Technical Bulletin

TB20231201 2023/12/26

Subject: Notice of terminating Copper Bridges(Jumpers) on VFD Compressors.

RC2-710B~930A/B

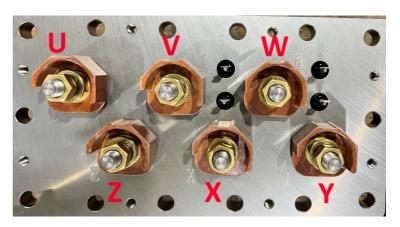
Since the issue of TB20230701, for compressors with VFD, the copper bridges are considered as compressor accessories. With our new policy, starting from January 1st, 2024. HANBELL will cancel the copper bridges as standard accessories.

In the following contents, we will provide alternative method to connect the VFD via SIX electric wires instead of THREE electric wires.

- 1. SIX electric wires need to be fixed on SIX terminal bolts with correct torque value correctly.
- 2. Combine the TWO wires as following then connecting to VFD.
- *U & Z wired together.
- *V & X wired together.
- *Y & W wired together.
